July 8, 2025
File: 23403-A/B/C
R3

**Re: Preliminary Geotechnical Comments: Septic Infiltration – Proposed Subdivision Development
Pinnacle Ridge, Anmore, BC**

As part of the submission of the Rezoning Addendum for the Pinnacle Ridge Hillside Development Application, we understand the Village of Anmore has requested comment on the feasibility of septic infiltration from a hydrogeological perspective. The relevant geotechnical item #4 submitted by the Village of Anmore via email on June 17, 2025, is shown below in italics and is followed by our corresponding review and response.

Figure 1 – Groundwater Levels recorded using Automated Pressure Transducers

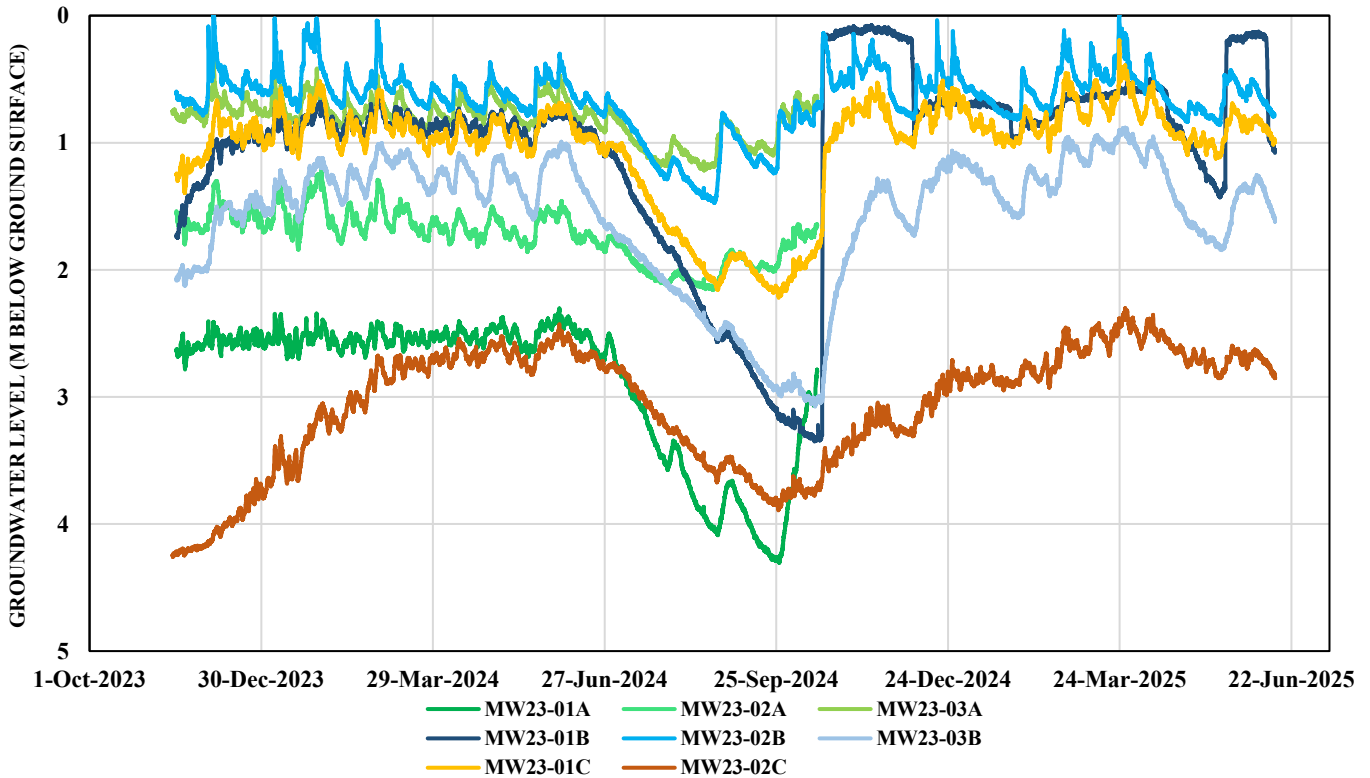
Figure 1, shown previously, presents the groundwater monitoring results relative to ground surface at each of the monitoring wells. The water levels have been presented in m below ground surface for simplification, due to the considerable variation in elevations across the site.

Based on the data presented on Figure 1, groundwater levels are at their highest between November 2023 to June 2024 and October 2024 to April 2025. The lowest groundwater levels are observed in September to October 2024 at all monitoring well locations. This is consistent with our understanding of seasonal variation in groundwater levels whereby groundwater elevations generally increase through the wetter winter months and decrease during the drier summer months.

The groundwater trends presented above are representative of typical variation in perched groundwater in shallow glacial till soils. The groundwater levels presented would suggest that, depending on the time of year of excavation, that shallow perched groundwater may be encountered during excavation at depths of between about 0.3 m and 4.2 m.
